To: T10 Technical Committee
 From: Rob Elliott, HP (elliott@hp.com)
 Date: 18 April 2006
 Subject: 06-189r0 SAS-2 Allow table-to-table expander attachment

Figure 2 — Expander device

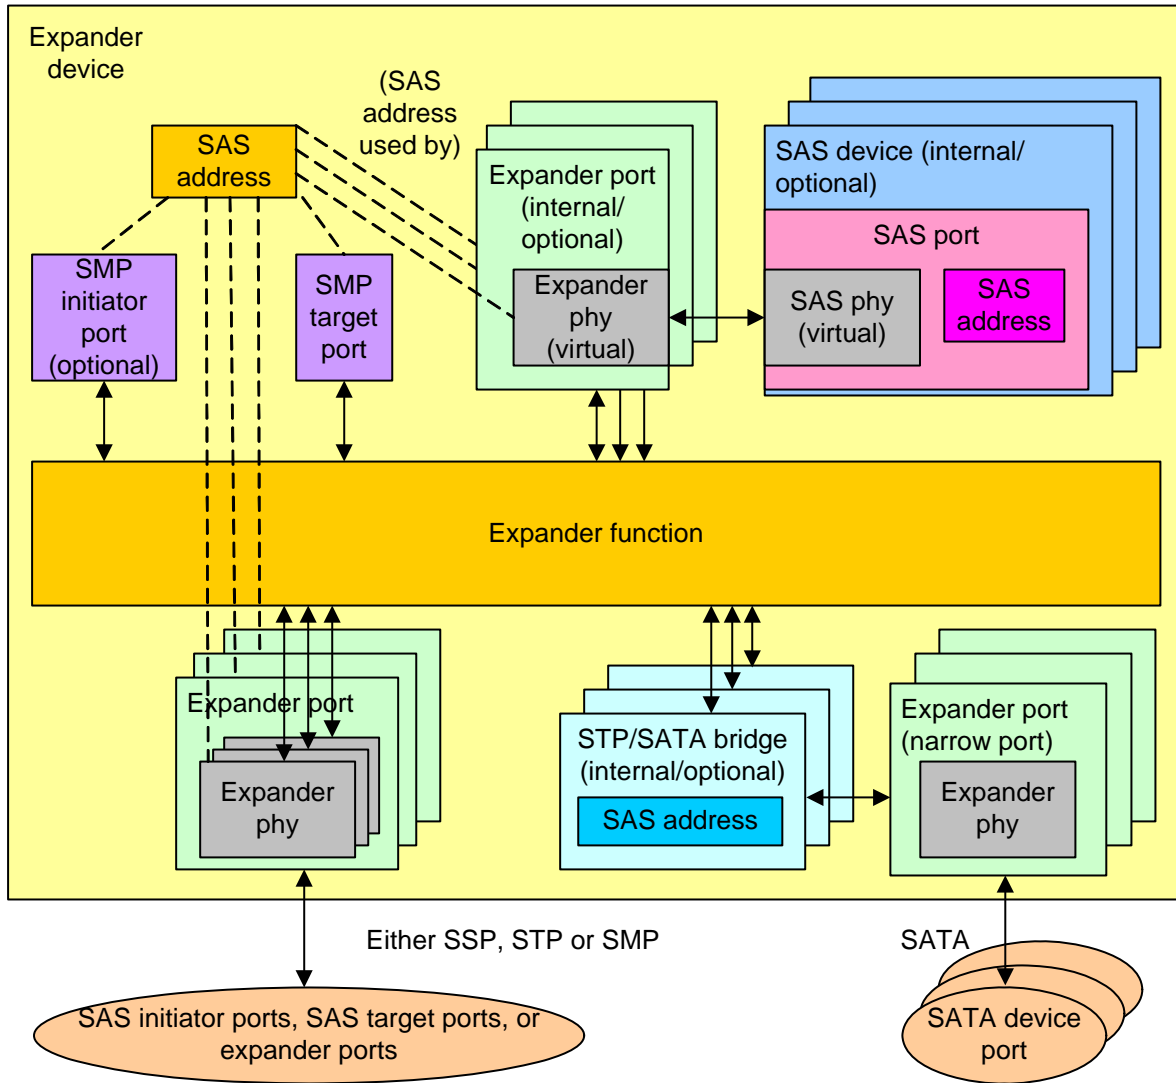
Editor's Note 1: in the figure, note that the SMP initiator port is mandatory in a self-configuring expander device

Figure 3 — Expander device class diagram

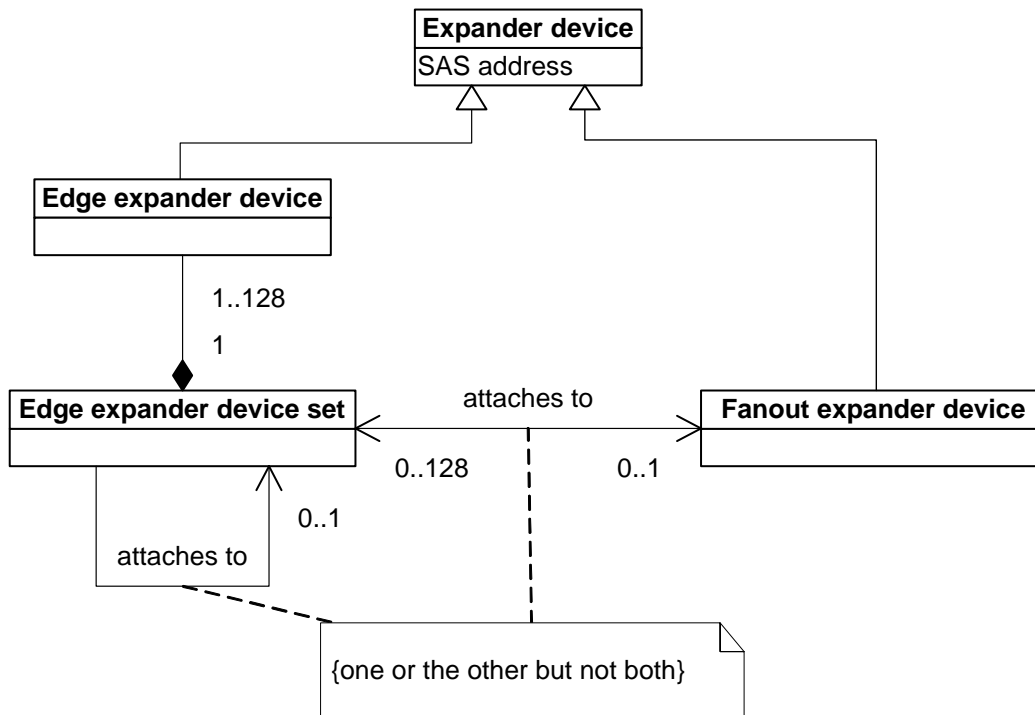
Editor's Note 2: The UML needs to show fanout expander devices attached to fanout expander devices

Figure 4 — Edge expander device set

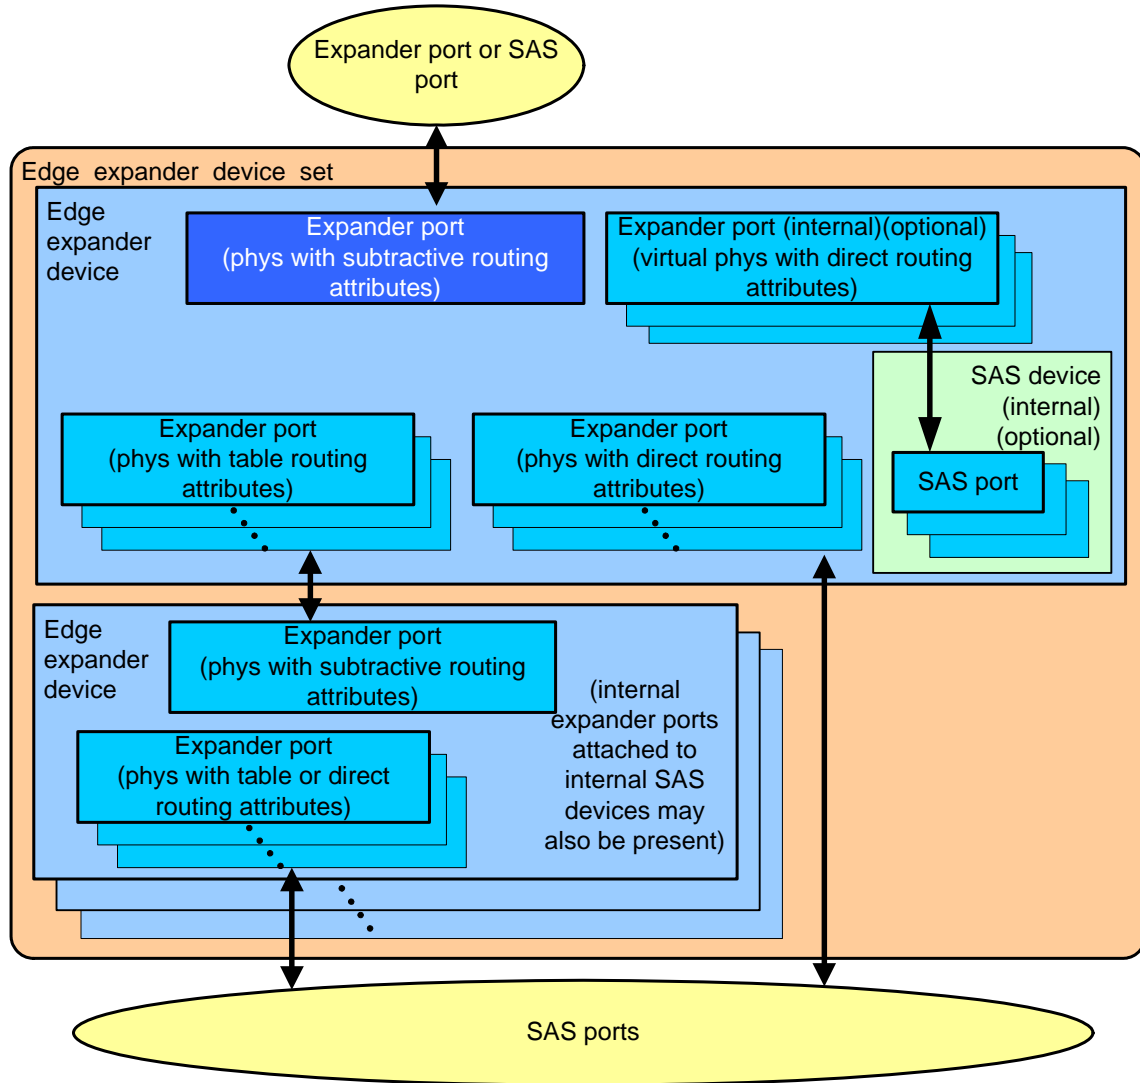
Editor's Note 5: show that upstream table routing is also allowed, as long as it does not go to another edge expander device set

Figure 5 — ~~Maximum~~ Single fanout expander device ~~set~~ topology

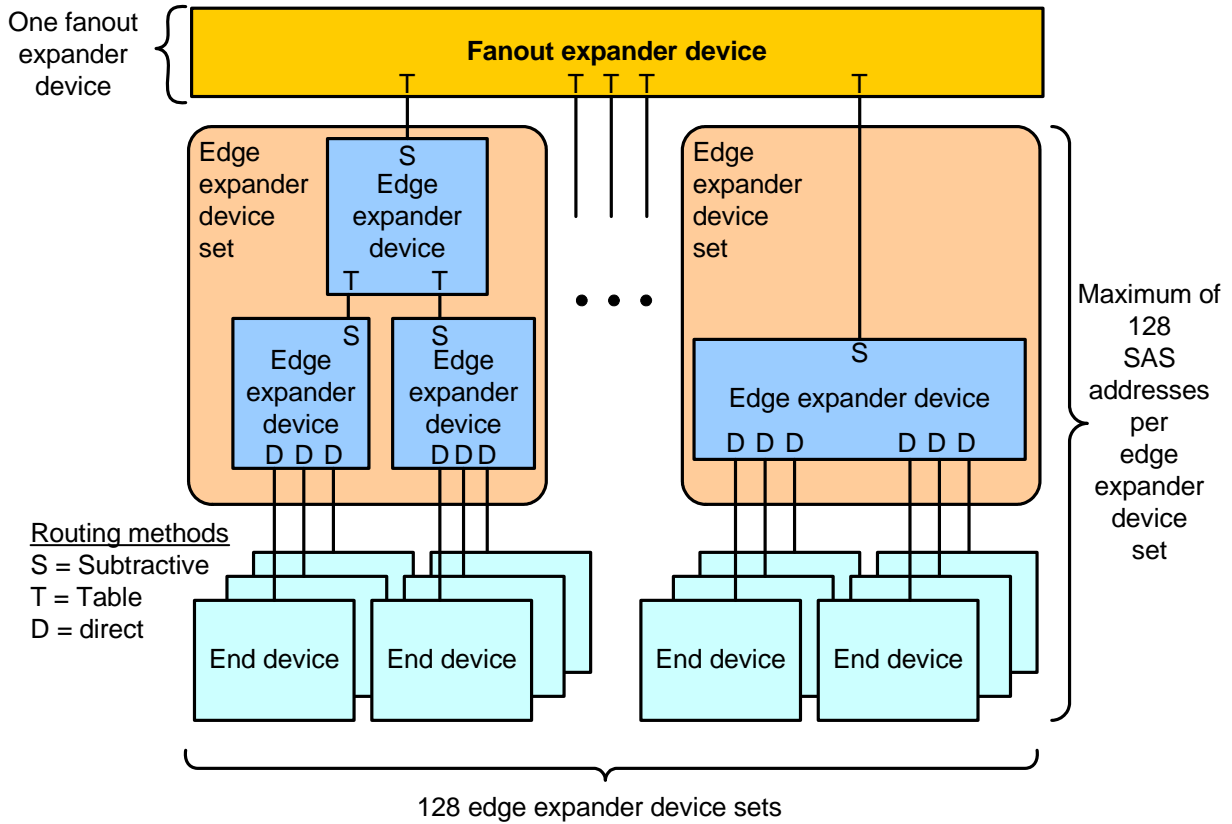
Figure 5 shows a SAS domain with ~~the maximum number of~~ one fanout expander device and 128 edge expander device sets.

Editor's Note 6: more examples are needed showing upstream table phys and fanout-to-fanout

Figure 9 — Level-order traversal example

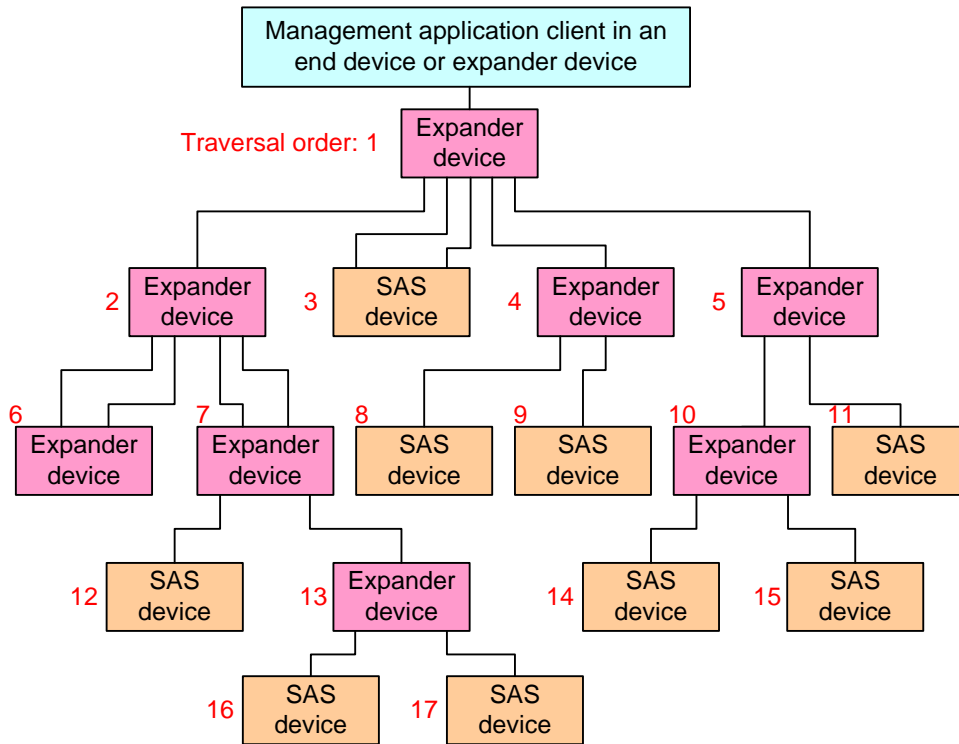
Editor's Note 8: Change "or expander device" to "or self-configuring expander device" in the figure

Figure 15 — Mini SAS 4x cable plug connector that attaches to an enclosure out port

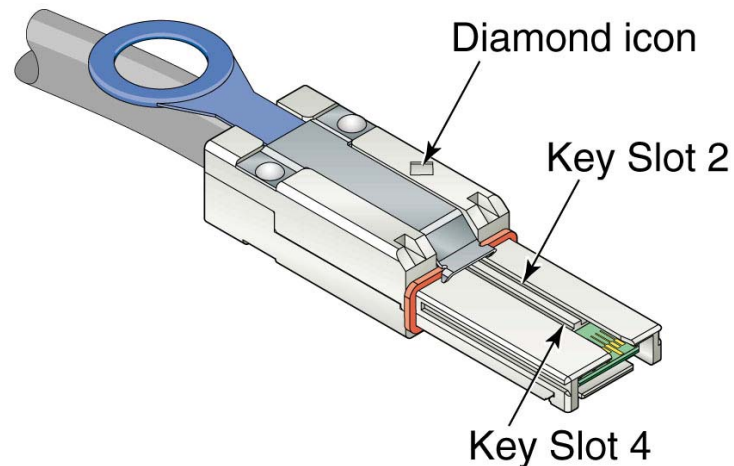
Figure 15 shows the key slots on the Mini SAS 4x cable plug connector that attaches to either an end device (see figure 17 in 5.2.3.3.2.2) ~~or~~ an enclosure out port (see figure 18 in 5.2.3.3.2.2) [or an enclosure in/out port](#).

Figure 16 — Mini SAS 4x cable plug connector that attaches to an enclosure in port

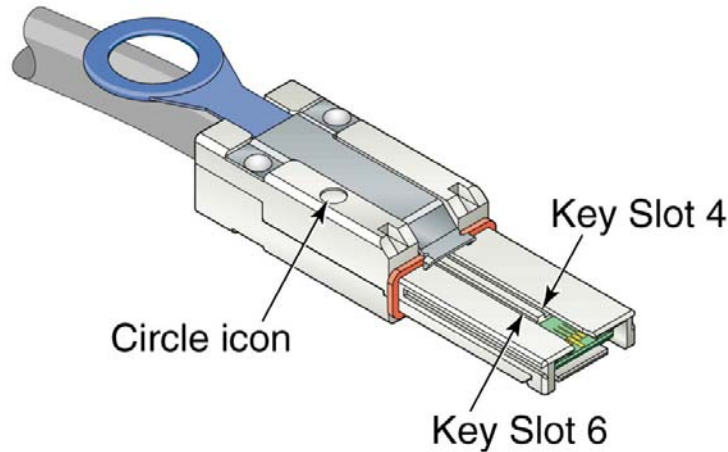
Figure 16 shows the key slots on the Mini SAS 4x cable plug connector that attaches to either an end device (see figure 17 in 5.2.3.3.2.2), ~~or~~ an enclosure in port (see figure 19 in 5.2.3.3.2.2), or an enclosure in/out port.

Figure 17 — Mini SAS 4x receptacle connector - end device or enclosure in/out port

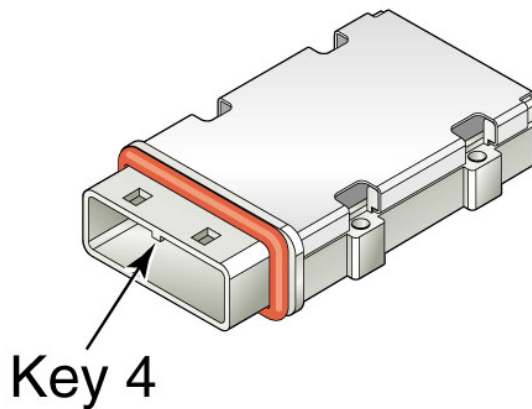
Use	Icons	Key position	Reference
End device <u>or enclosure in/out port</u>	Diamond and circle	4	Figure 17
Enclosure out port (see 4.6.2)	Diamond	2	Figure 18
Enclosure in port (see 4.6.2)	Circle	6	Figure 19

Figure 17 shows the key on a Mini SAS 4x receptacle connector used by end devices. This connector may be attached to the Mini SAS 4x cable plug shown in figure 15 or the Mini SAS 4x cable plug shown in figure 16 (see 5.2.3.3.2.2).
